1. Combined Timing Constants

2. Suggested Changes

Based on our consensus review at the PHYDOG's meeting in Albuquerque, the following modifications are proposed for P1394a to clarify intent, correct errors, etc.

Figure 1 —Start of packet transmission (first of a possible concatenated sequence)

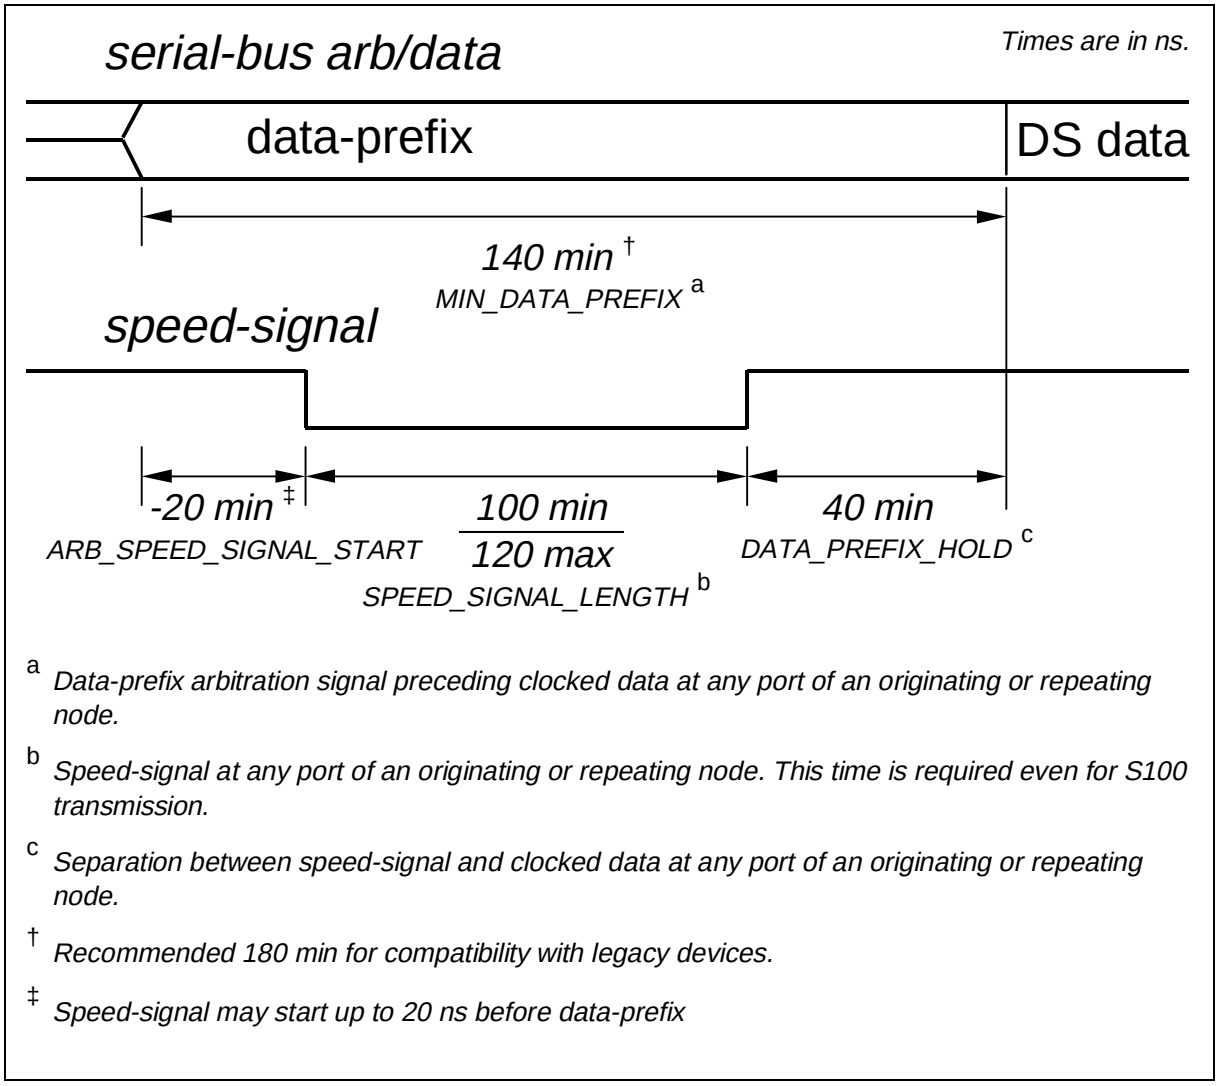
This parameter only applies to the first packet after IDLE or RX_GRANT. Said differently, this parameter does not specify the relationship of the speed signaling to the DATA_PREFIX of concatenated packets. As such, the comment should be clarified and a reference to the figure added:

This parameter only applies to the first packet after IDLE or RX_GRANT. Said differently, this parameter does not specify the duration of DATA_PREFIX in between concatenated packets. As such, the comment should be clarified and a reference to the figure added:

The speed signaling period must be guaranteed by any transmitting port. This is true even in the case of S100 when no speed code is actually signaled. The comment should clarify this requirement and reference the new diagrams:

> Time delay between a transmitting port generating the DATA_PREFIX signal and the same transmitting port generating the transmission speed signal for the first packet in a possible concatenated sequence. See Figure 1.

> The total time an originating port transmits a TX_DATA_PREFIX signal prior to clocked data. This constant is not applicable to data prefix that precedes a concatenated packet (see CONCATENATION_PREFIX_TIME). See Figure 1.

> Duration of speed signaling at a transmitting port. See Figure 1 and Figure 2.
> (~10/BASE_RATE)
>
> **Important:** This time period is required for S100 packet transmission even though an explicit speed signal is not sent.

Figure 2 —Concatenated packet transmission

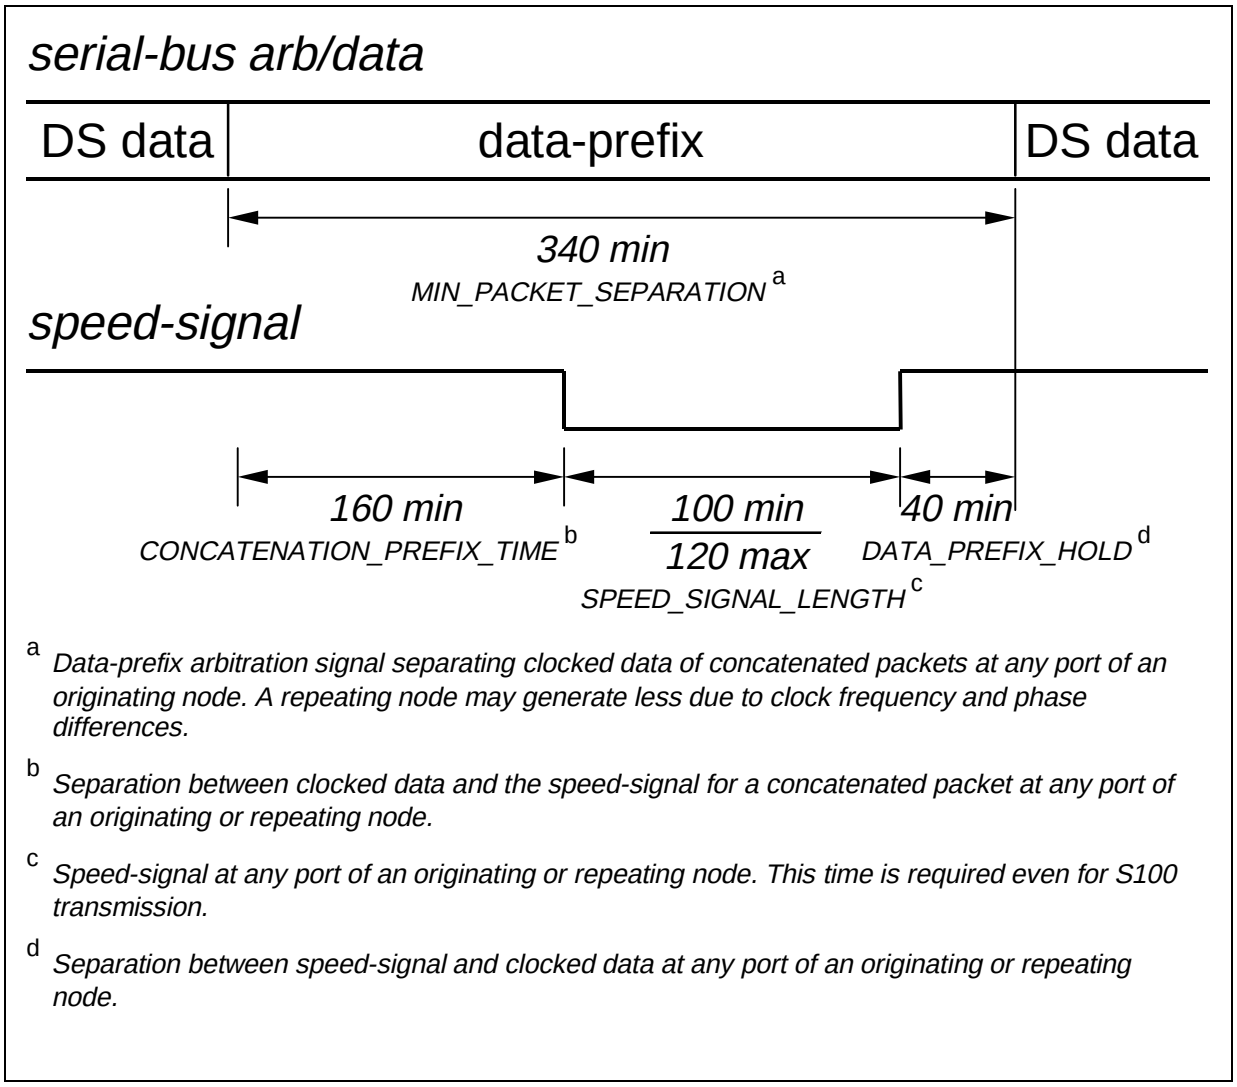
When transmitting concatenated packets, originating and repeating PHY's shall ensure that CONCATENATION_PREFIX_TIME + SPEED_SIGNAL_LENGTH + DATA_PREFIX_HOLD is met even when no speed-signaling is present. The comment for DATA_PREFIX_HOLD should be adjusted to suggest that the speed signaling time is always required and to reference the appropriate figures:

This parameter only applies to the duration of DATA_PREFIX between concatenated packets and is only enforced at the node that originates the concatenation. Also, the originally specified guideline of ~32/BASE_RATE is in error. The .34 µS minimum is actually closer to ~34/BASE_RATE. The comment should also include a reference to the new figure:

> At a transmitting port, the time between the end of the speed signaling time and the start of clocked data. See Figure 1 and Figure 2.

> The total duration of the TX_DATA_PREFIX signal separating clocked data of concatenated packets at any port of an originating node. See Figure 2.
> (~34/BASE_RATE)

Figure 3 —End of packet transmission

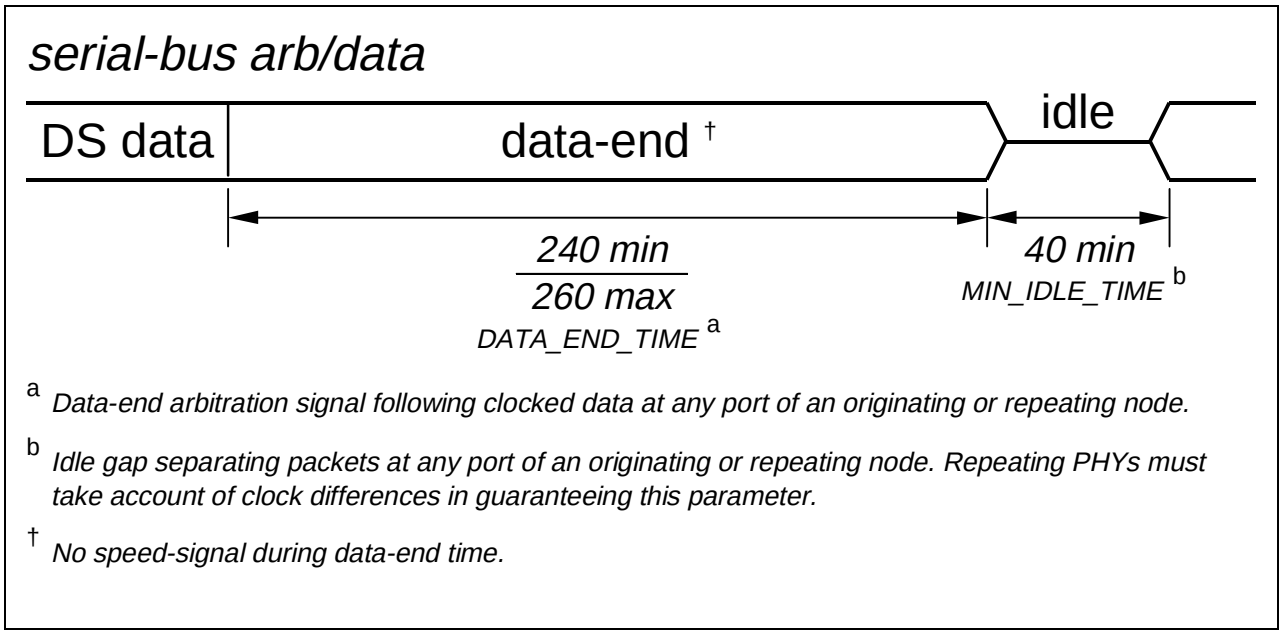
When transmitting concatenated packets, originating and repeating PHY's shall ensure that CONCATENATION_PREFIX_TIME + SPEED_SIGNAL_LENGTH + DATA_PREFIX_HOLD is met even when no speed-signaling is present. The comment for CONCATENATION_PREFIX_TIME should be adjusted to suggest that the speed signaling time is always required and to reference the appropriate figure:

A figure illustrating the end of packet transmission has been prepared and should be referenced in the comment:

All nodes must enforce a minimum idle gap after the DATA_END of a packet sequence. This minimum time used to be accounted for by the minimum ACK_RESPONSE_TIME. However, ACK_RESPONSE_TIME and the new MAX_RESPONSE_TIME only apply at the originating node. Consequently, a new parameter that applied at every transmitting port was required. The definition of MIN_IDLE_TIME is:

> At a transmitting port, the time between the end of clocked data and the start of the speed signaling time for the concatenated packet that follows. See Figure 3.

> End of packet signal time (~24/BASE_RATE). See Figure 3.

> Idle gap separating packets at any port of an originating or repeating node. See Figure 3.

Figure 4 —Response Time to prevent detection of a subaction_gap

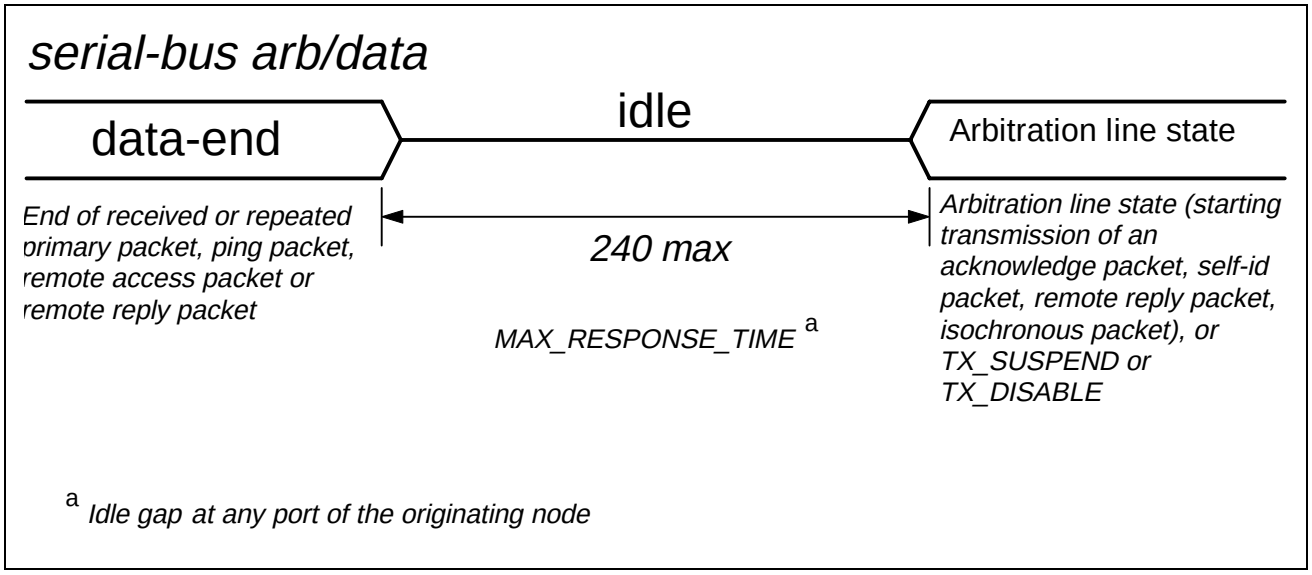
Per the Albuquerque PHY designer's review session, this parameter is intended to subsume the PING_RESPONSE_TIME and specifies the time by which a node must commence any response required to be received before a subaction_gap is detected anywhere within the network. Responses which must be received within the same subaction include acknowledge packets, isochronous packets, remote reply packets, self-id packets, and TX_SUSPEND/TX_DISABLE indications. Consequently, the comment should be updated to:

> Idle time measured at the cable connector from the end of DATA_END that follows a primary packet, ping packet, remote access packet or remote reply packet to the start of the DATA_PREFIX for an ACK packet, a self_ID packet, a remote reply packet, an isochronous packet, or a TX_SUSPEND or TX_DISABLE. See Figure 4.
